Item No. 8.1.1
Design Review Committee
July 7, 2016

SUBJECT: Case 20374: Substantive Site Plan Approval – 5673-5681 Brenton Place and
1448-1468 Brenton Street, Halifax

Attachment A – Site Plan Approval Plans

SITE PLAN APPROVAL APPLICATION

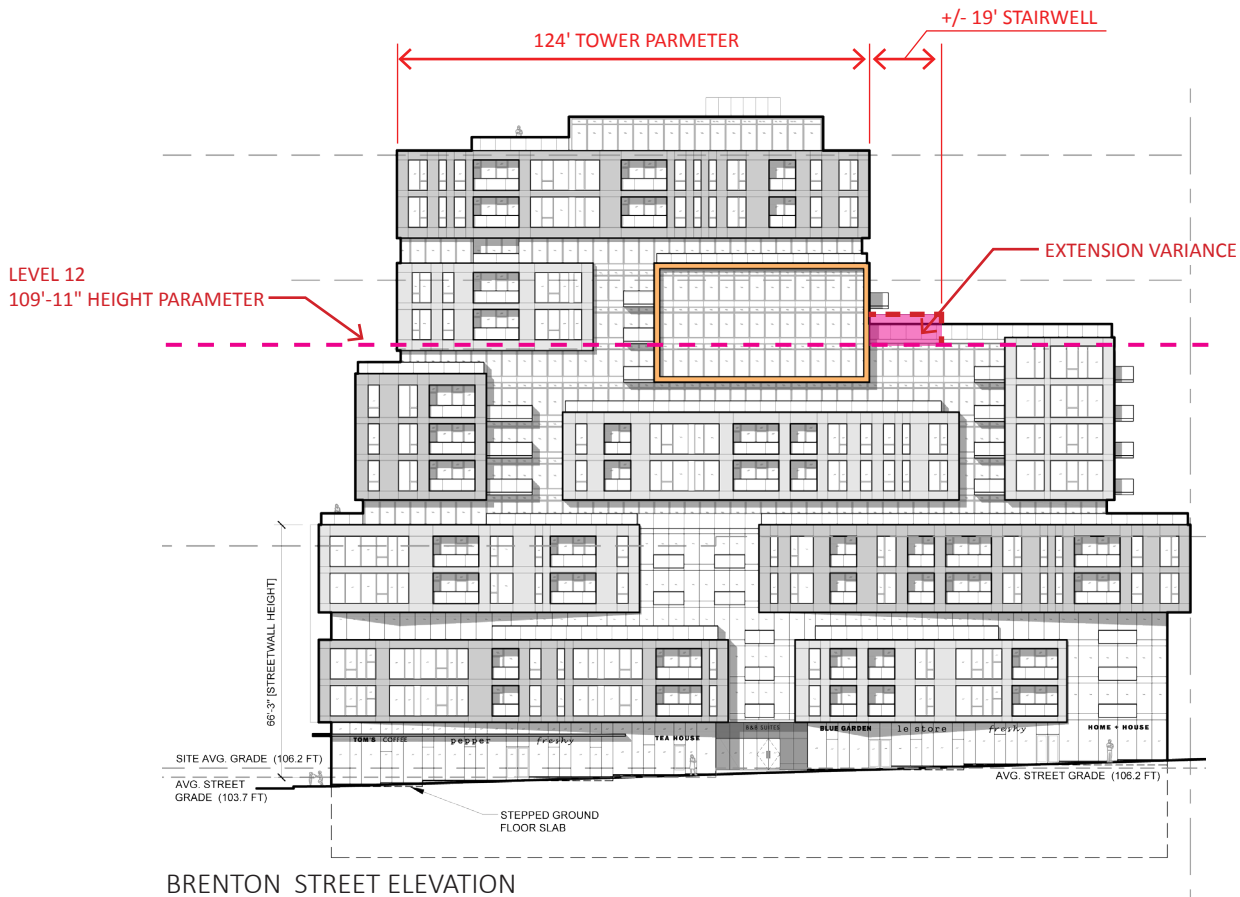
Section 10(10) of the LUB stipulates that any portion of a building above a height of 33.5m, as identified in Map 8, shall be a maximum width and depth of 38m. Within the proposed design, the exterior enclosed staircase on level 12 exceeds the maximum width by 5.8 metres (19 feet).

The proposed exit staircase does not result in additional floor area and is required for building code purposes. It will not be visible from ground-level and will not result in a change to the appearance of the tower portion of the building. The proposed variance is consistent with the objectives of the Design Manual.

3.6.15 LAND USES AT GRADE VARIANCE (GROUND FLOOR CEILING HEIGHT)

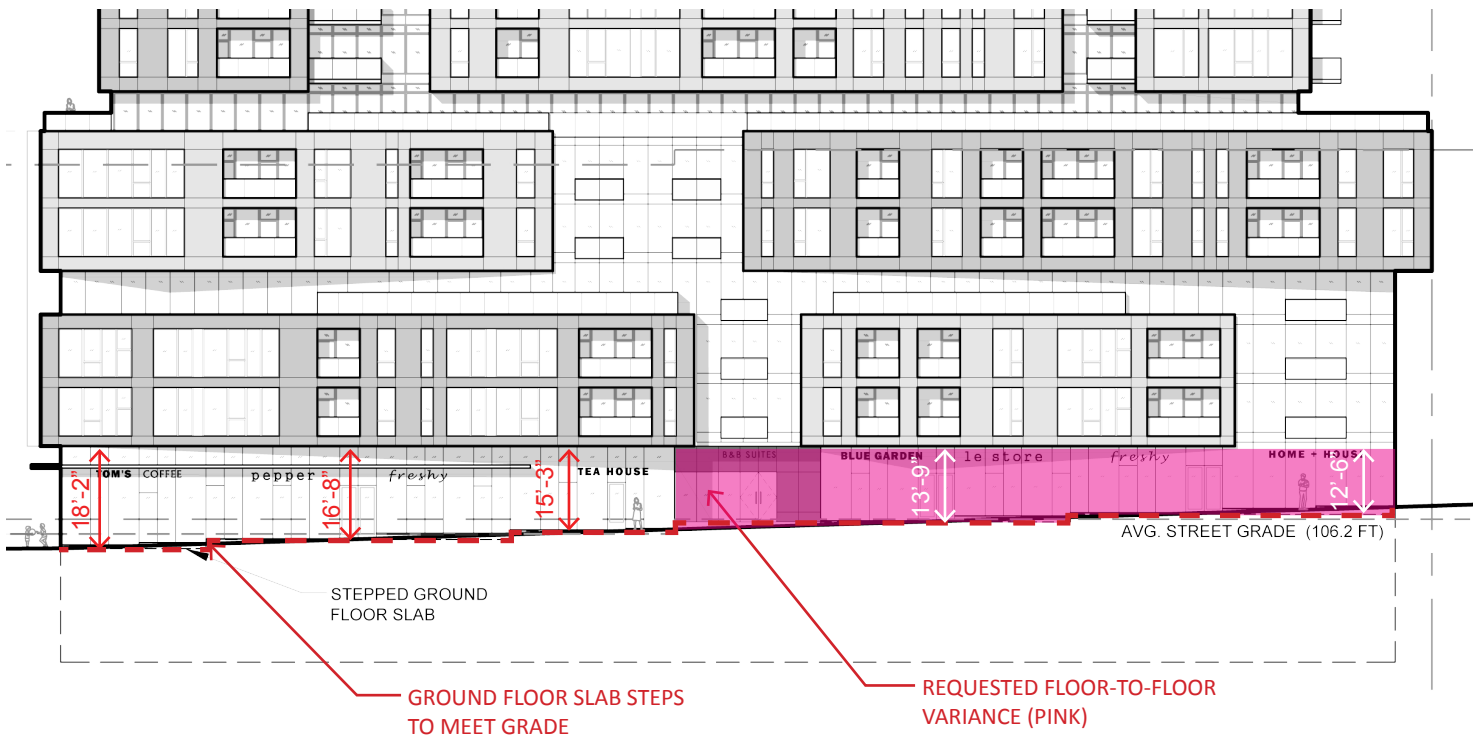
Section 8(13) of the LUB requires a minimum ground floor height of 4.5 metres (14.75 ft.). The ground floor height within the proposed development ranges between 5.5 metres (18 ft.) facing Brenton Street on the southern end, but reduces to 3.8 metres (12.5 feet) at the northern end of the building.

Due to the long street frontage along Brenton Street and a drop in elevation of 2.1 metres (7 feet), the site poses difficulty in achieving a 4.5 metre floor height across its entire length. The proposal does include dropping the floor slab to meet grades, thereby not resulting in a sunken ground-floor condition. No variance is required along Brenton Place. The proposed reduction in the ground-floor height along Brenton Street is consistent with the objectives of the Design Manual.
